**CITY OF FLORENCE
PLANNING COMMISSION**

RESOLUTION PC 23 28 VAR 01

A REQUEST FOR DESIGN REVIEW FOR NEW SINGLE-FAMILY ATTACHED DWELLINGS AS PART OF THE PINE CROSSING SUBDIVISION AND A VARIANCE TO MAXIMUM 12' DRIVEWAY AND GARAGE WIDTH.

**FINDINGS OF FACT (Proposed)
FLORENCE PLANNING COMMISSION
Exhibit "A"**

Figure 1. Dwellings are proposed to have a 9' tall screen wall in the driveway nearest the garage.

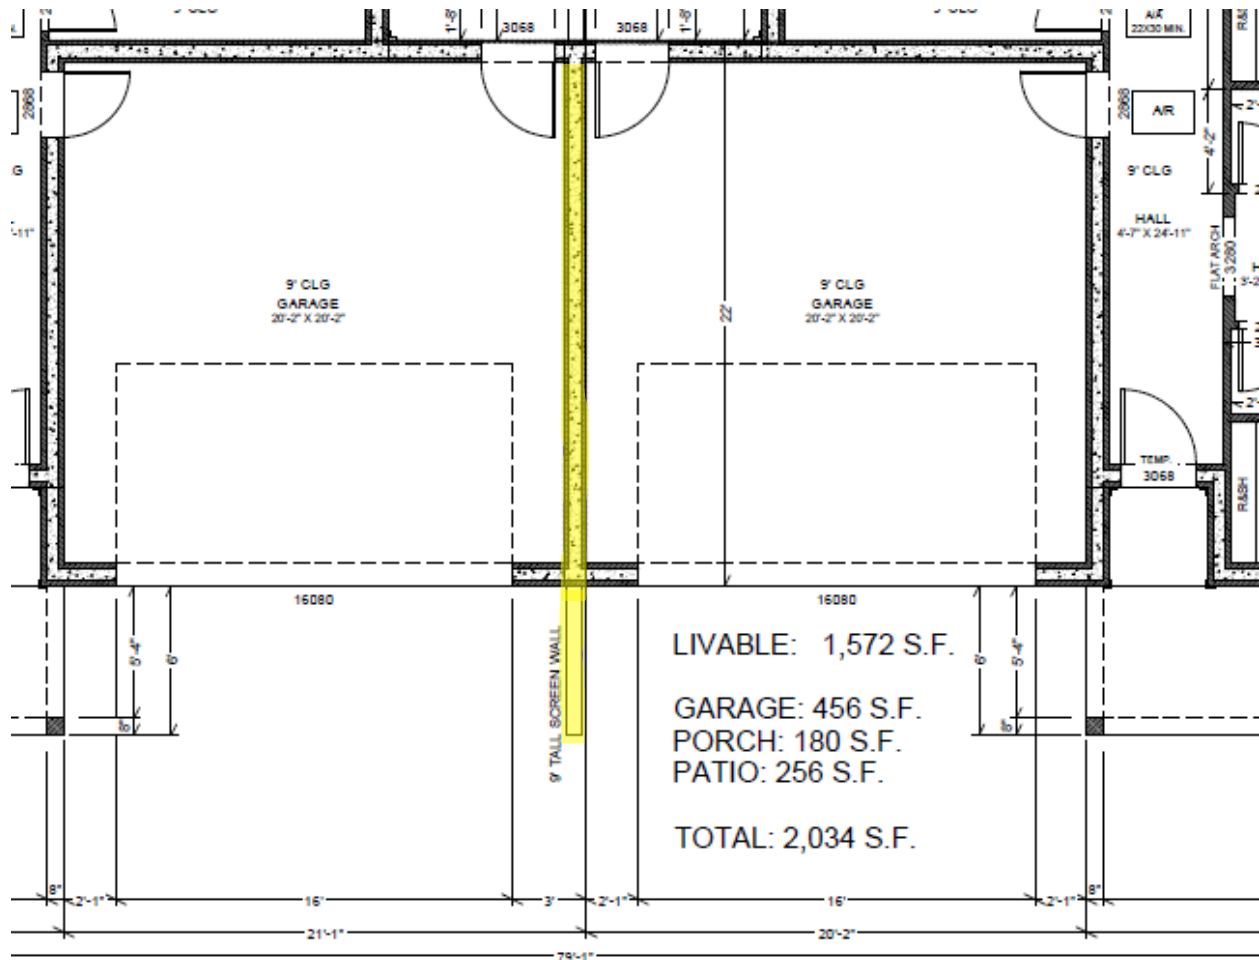
The attached single-family units meet or exceed the requirements of FCC 10-34-5
 Fences proposed on the side and rear yards at six feet in height or less. The common garage wall in the driveway is 9-feet in height and exceeds the maximum height allowed in a front yard. Per FCC 10-34-3-7-A, buffering or screening in a parking and maneuvering area is limited to a maximum of 4-feet in height. The applicant shall submit revised architectural plans showing the buffer/screen on the common side lot line a maximum of 4-feet in height. This has been added as a condition of approval. Criterion conditionally met.

- 2.1. Prior to issuance of building permits, applicant shall submit revised architectural plans showing buffer/screen, located on the common side lot line in the driveway of the dwellings, a maximum height of 4-feet in accordance FCC 10-34-3-7-A.

Figure 4. Driveway exceeds 12'. Applicant proposing variable width driveway between 16-18'.

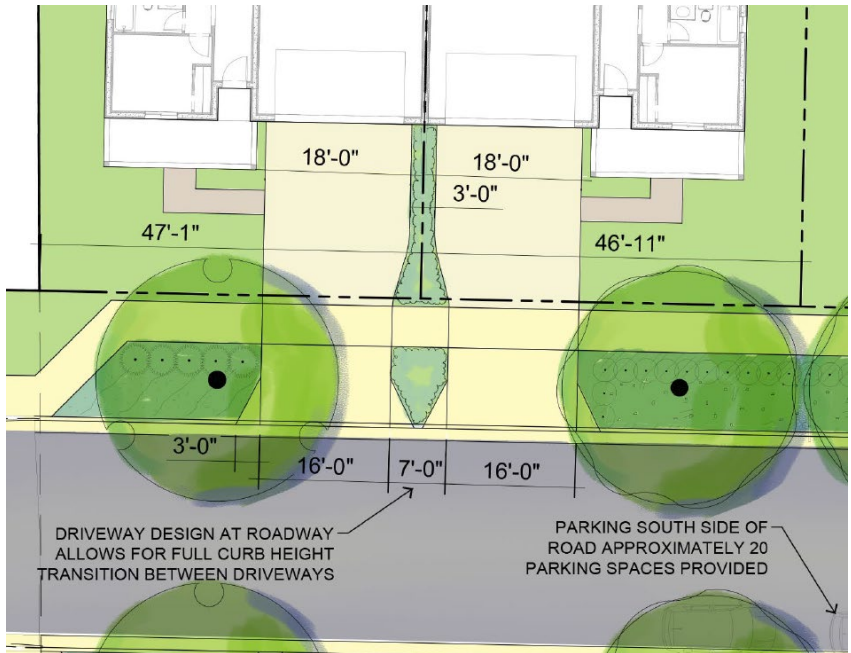
As seen on Figure 4, the proposed outdoor on-site parking and maneuvering area exceeds 12-feet. The applicant is proposing an outdoor on-site parking and maneuvering area that is 18-feet, at its widest point nearest the garage entrance, and tapers to 16-feet near the street. The proposed off-site parking and maneuvering area accounts for an average of 33% of the lot frontage. See Figure 4 below.

Because the applicant does not meet the code requirement of FCC 10-3-8-A, a variance is necessary to permit the applicant's proposed off-site and maneuvering area and garage width. The variance request will be discussed as part of these findings.

Figure 5. Driveway accounts for an average of 33% of the lot frontage.

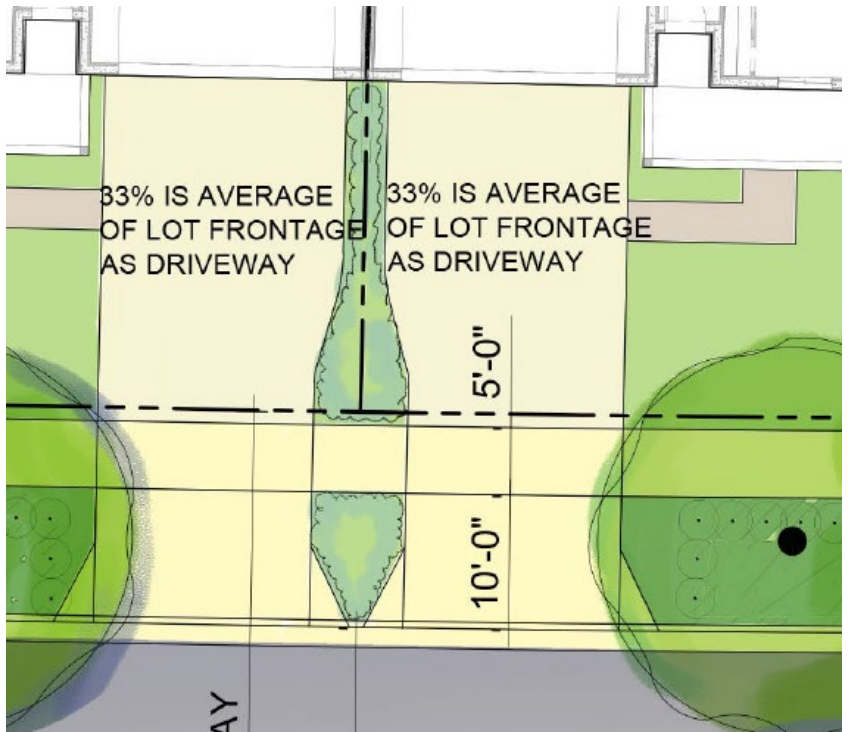
The applicant offers a reasonable explanation of the proposed garage off-street parking and maneuvering areas and how they meet the spirit and intent of FCC 10-3-8.

Figure 6. Proposed garage widths exceed 12'.

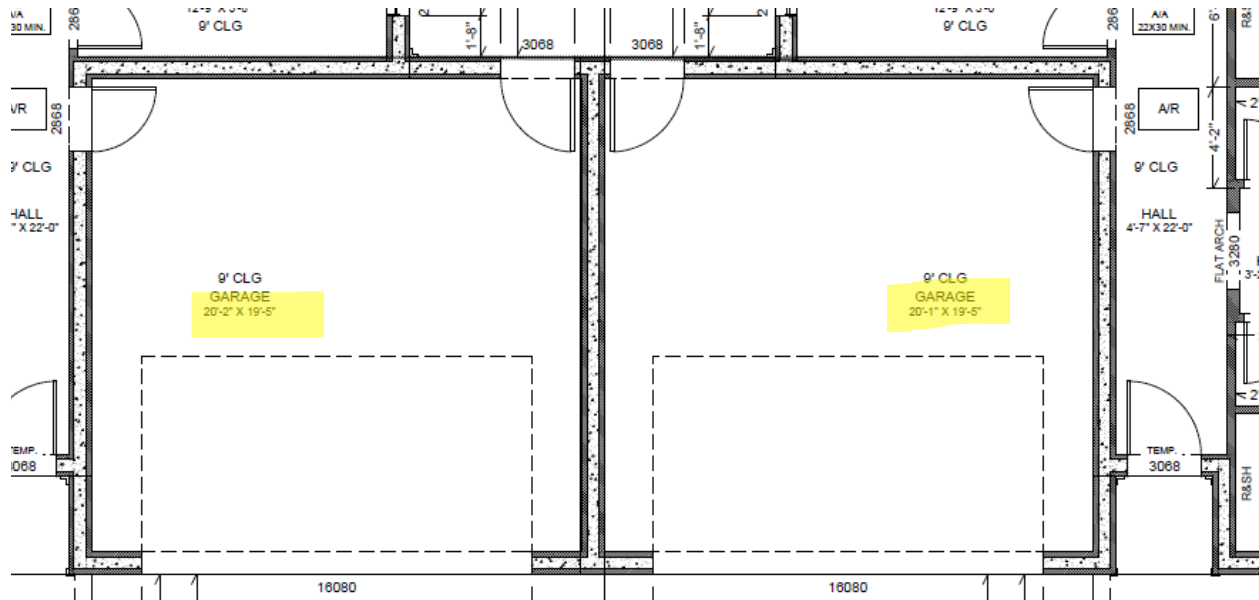
As seen in Figure 6, the applicant's proposed garage width exceeds 12'.

The applicant has not addressed the deviation in garage width from the code requirements nor are they requesting a variance. City staff offer have offered an interpretation of FCC 10-3-A-1 as to how a garage width in excess of 12-feet may be permissible. See interpretation on Page 12-13 of these findings. Planning Commission is being asked to validate this interpretation. Additionally, at the time of this hearing edits to this criterion increasing the allowable number of covered spaces have been heard by the City Council at the recommendation of the Planning Commission. Code changes take effect within 30 days of approval.

Figure 13. Applicant's driveway, planter strip, and sidewalk proposal matches the example seen in Figure 10-35(2).

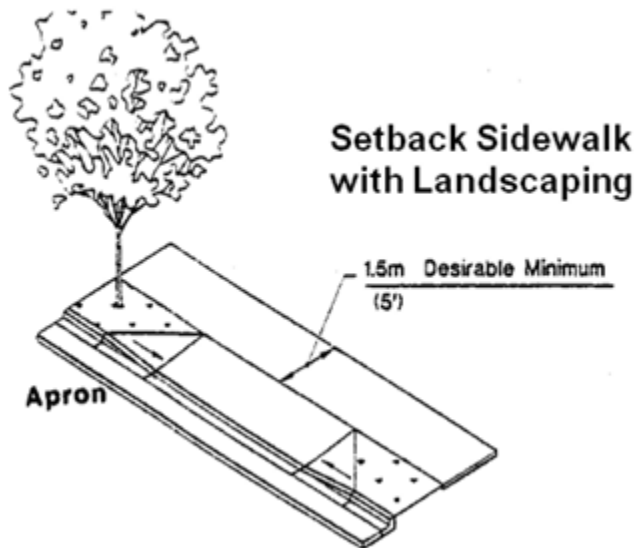
The applicant's proposal for driveways and sidewalks most matches the type seen in Figure 13. Driveways are subject to review and approval by the Public Works Director. Criterion met.

Figure 14. Vision clearance areas shall remain in compliance in perpetuity.

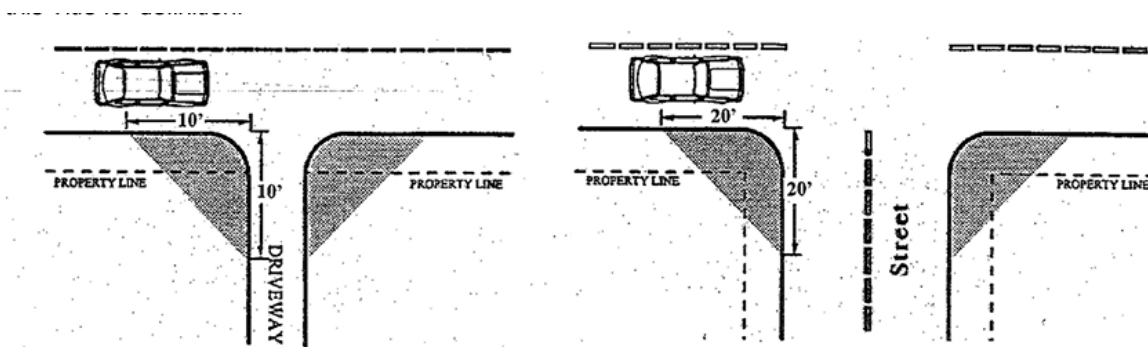
Vision clearance shall remain in place in perpetuity. The common buffer/screen located on the common property line is proposed to be 9-feet in height, which exceeds buffer/screen heights in the front yard. A condition of approval for the applicant to revise the height has been added to these findings. Street trees and shrubs proposed at intersections shall not obstruct the area between 2 ½ feet and eight feet in height in vision clearance areas. This will be an informational item.

TENTATIVE SUBDIVISION SITE PLAN

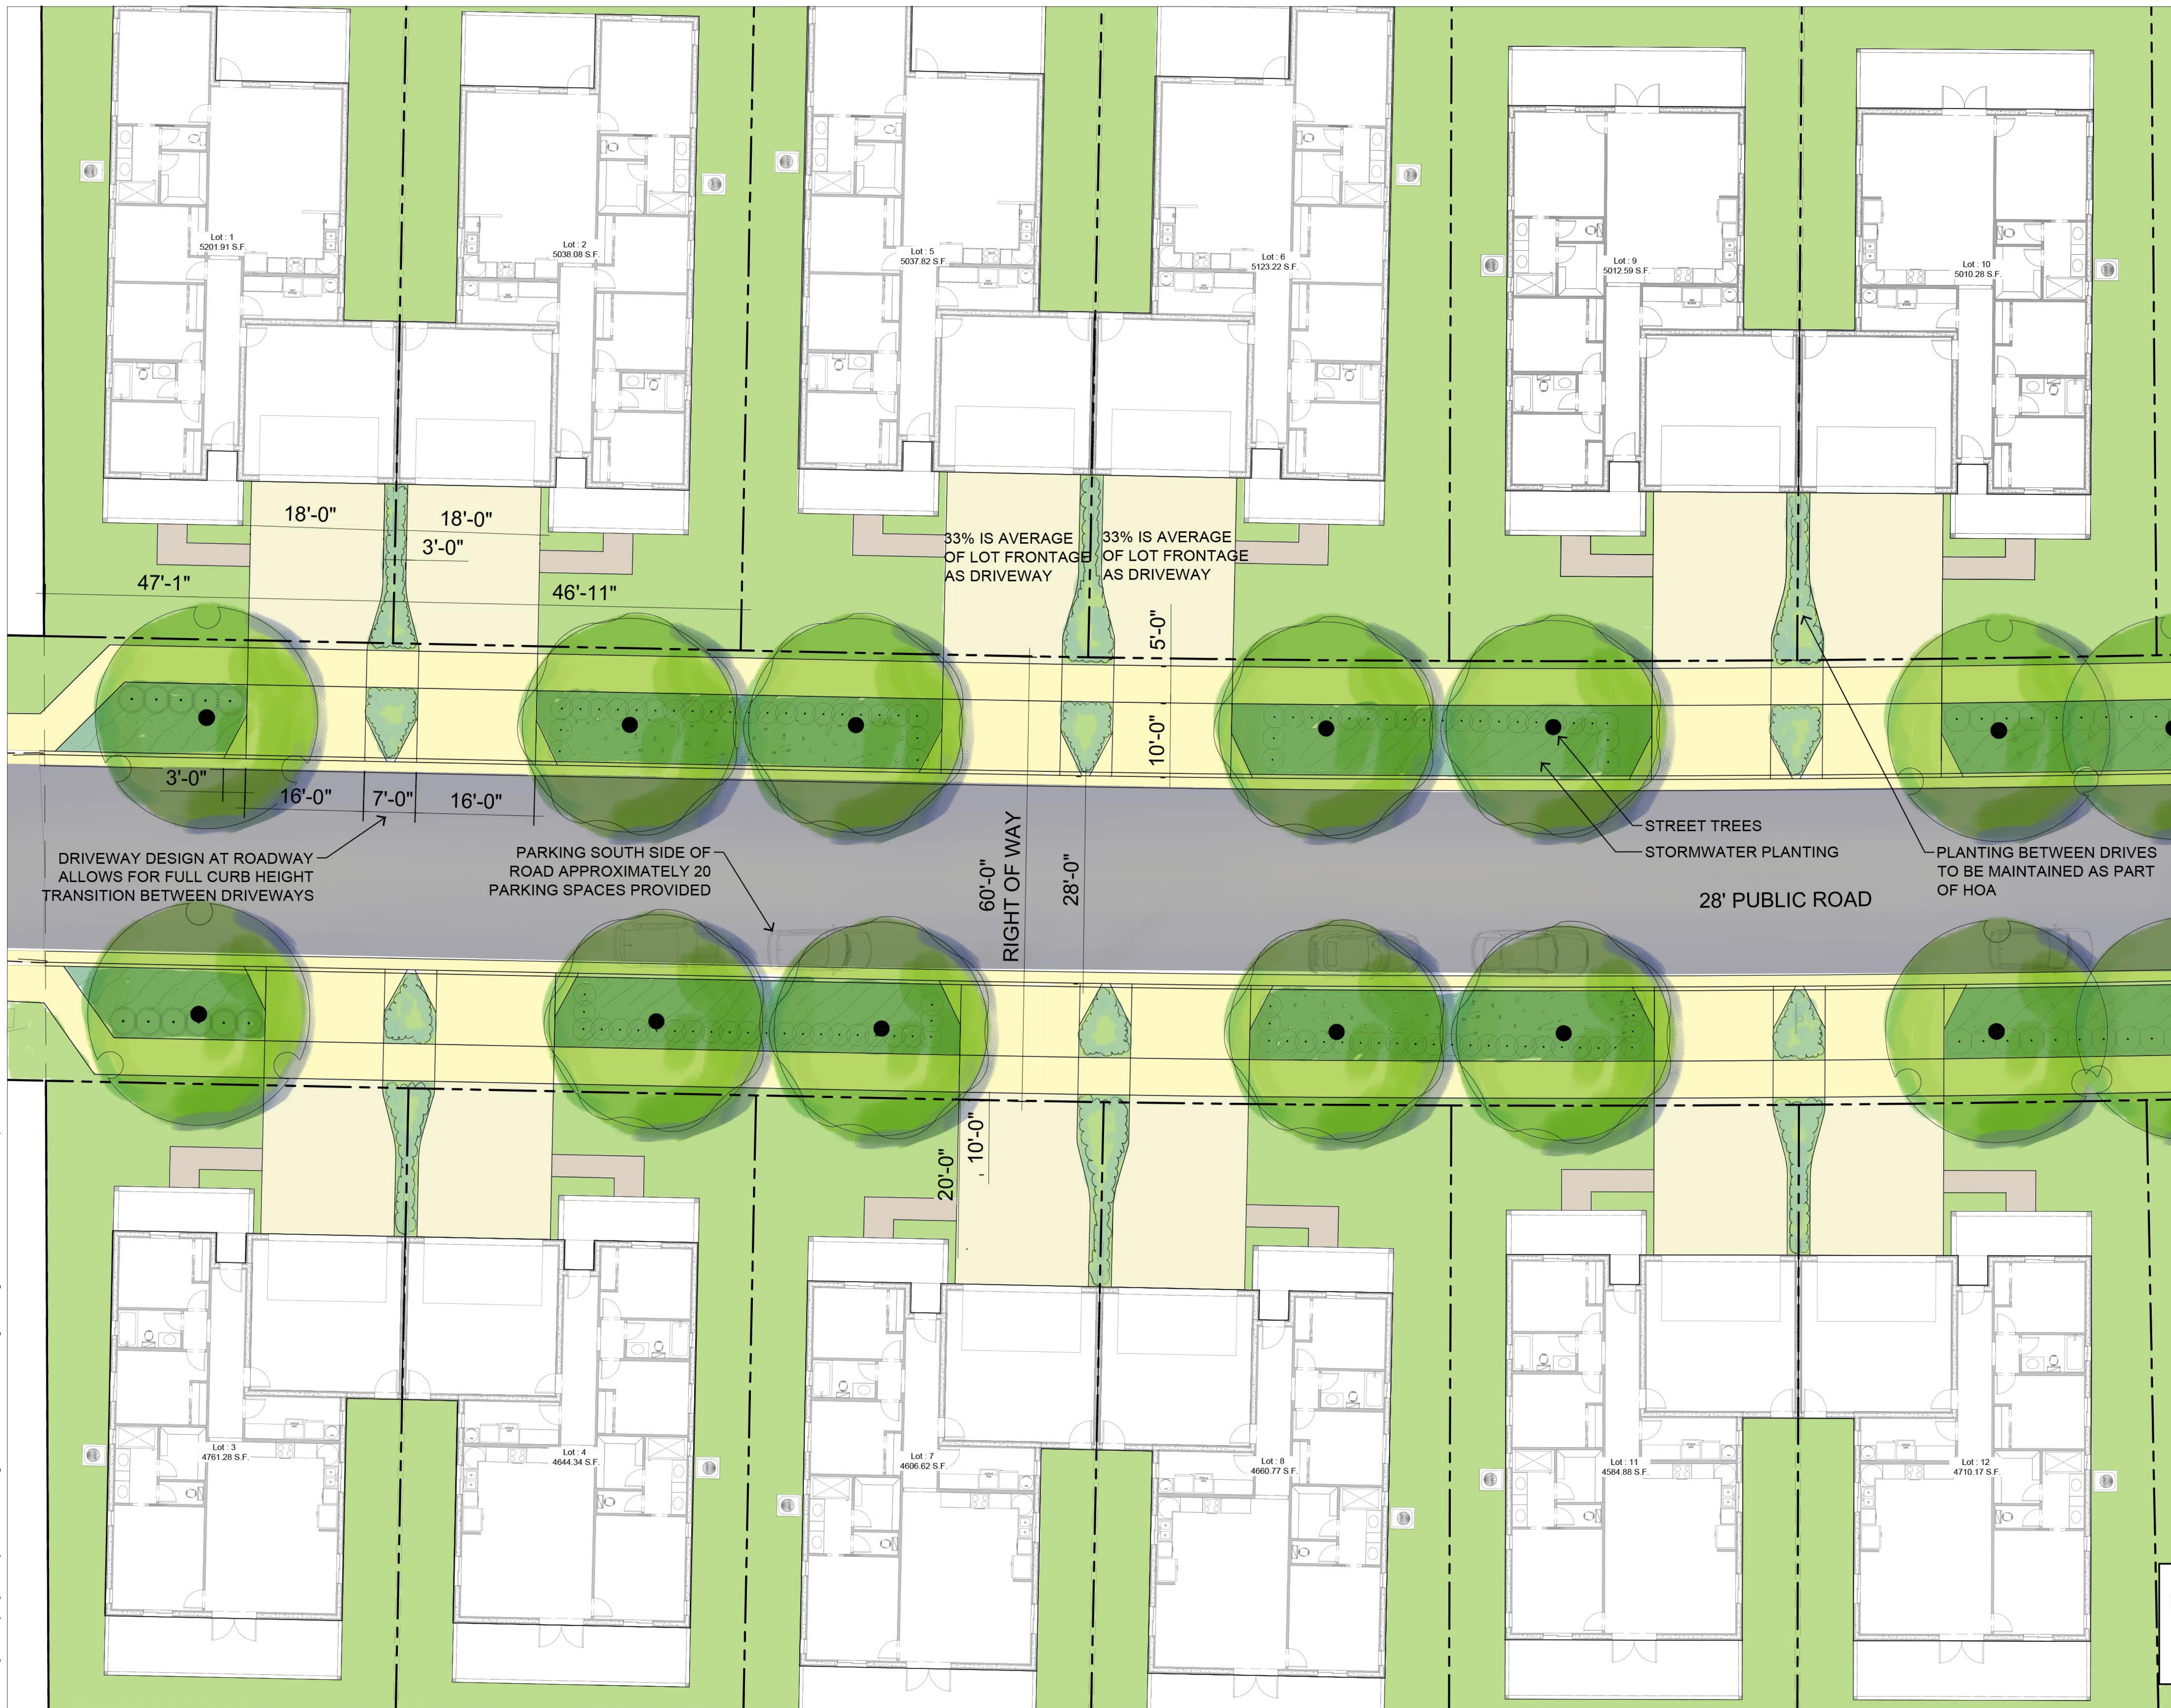
As seen on Sheet L3.0, the driveway distance from the intersection of the new 53rd Street (to be constructed as part of the Pine Crossing subdivision) and Spruce Street exceeds 35-feet (centerline of Spruce Street to landscaped median, separating driveways, on Lot 1 is approximately 100-feet). Criterion met.
